**FEDERAL AVIATION ADMINISTRATION  
AIRWORTHINESS DIRECTIVES**

**SMALL AIRCRAFT  
ROTORCRAFT, GLIDERS, BALLOONS, AND AIRSHIPS  
BIWEEKLY 2011-03**

*February 1, 2011*

**2011-01-53 PIAGGIO AERO INDUSTRIES S.p.A:** Amendment 39-16582; Docket No. FAA-2011-0054; Directorate Identifier 2010-CE-070-AD.

Figure 1. Additional drain holes on keel beam webs

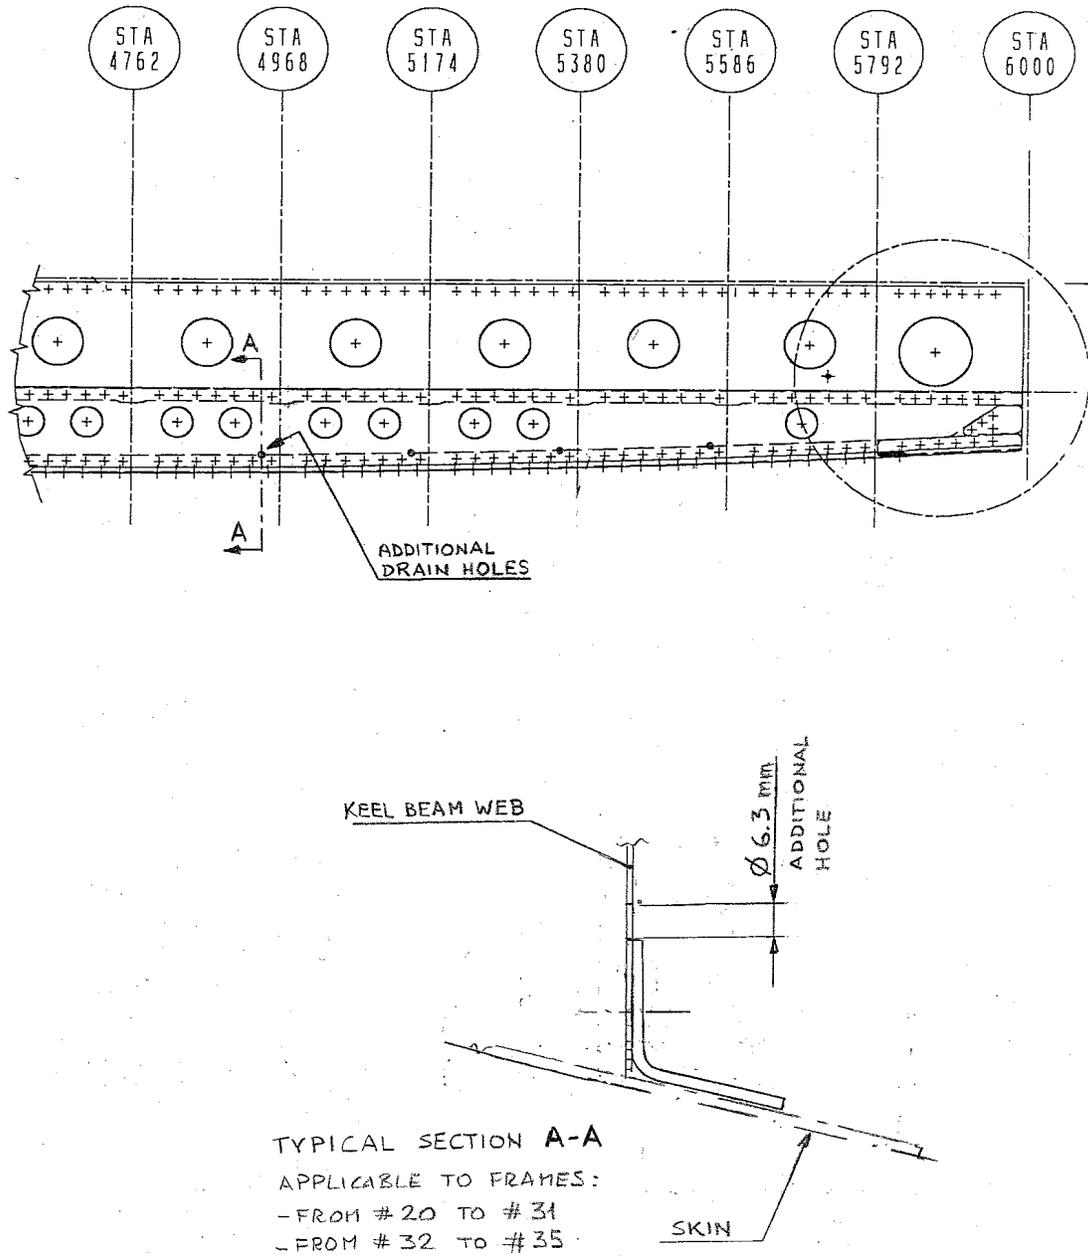
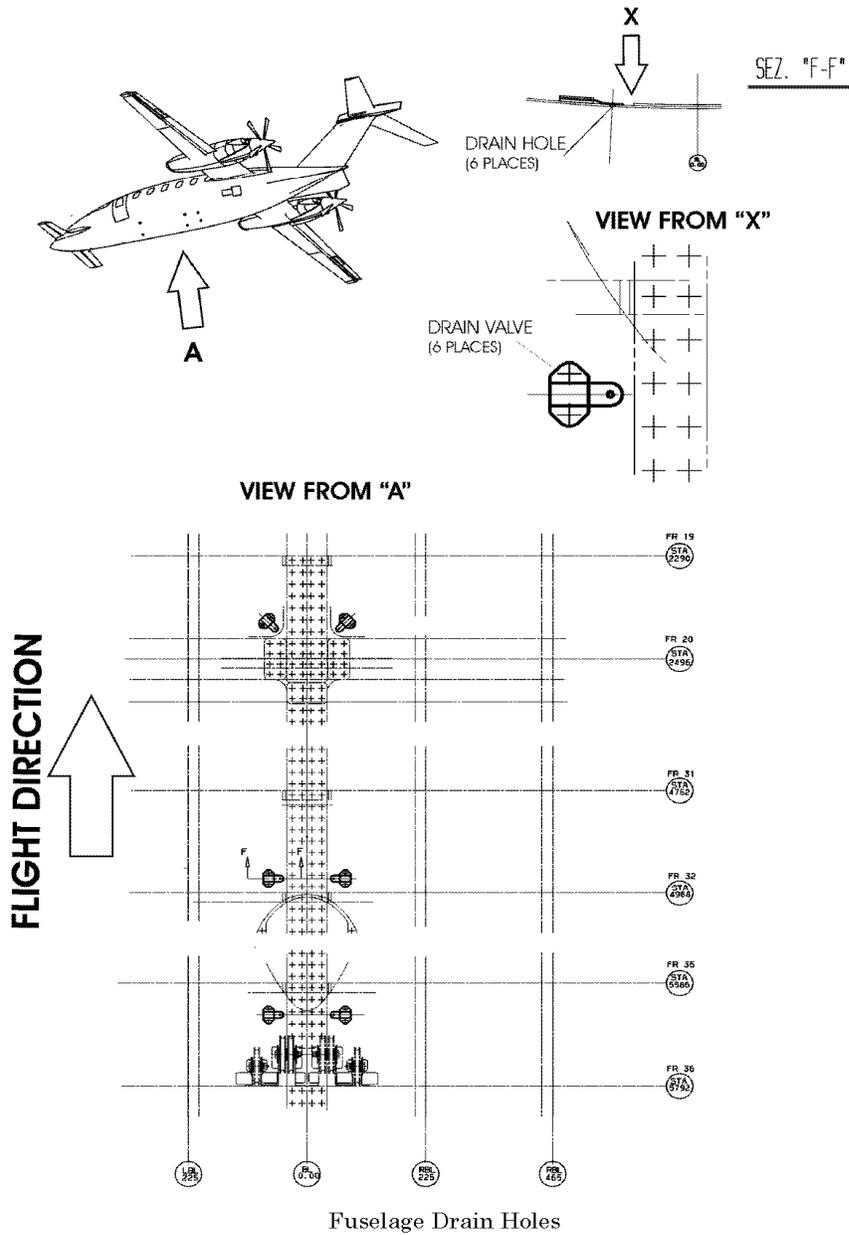
- ii. If water is found in excess of item above (4-c-i), do step 5.
5. Add 6.3 mm draining holes as per attached figure 1 (additional drain holes on keel beam webs) connecting the lateral bays to the center ones or, as alternative, apply Piaggio Aero Industries Service Bulletin 80-0291. Then proceed with step 6.
